RE: JMC Project 22062

AMS Buchanan

## Response to Village Engineer Comments

# A. Memorandum from David Smith (Planning & Development Advisors), dated 9/26/2025.

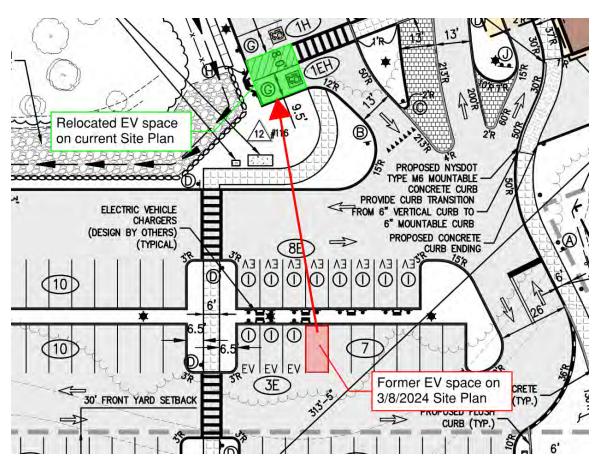
It appears the building outline, sidewalk in the fire lane, and EV space count have also changed. All changes should be identified on plans for evaluation.

The EV space count between the 3/8/2024 site plan and the current site plan has remained the same with 12 proposed. One of the EV spaces was relocated to be in the ADA space, see below graphic:
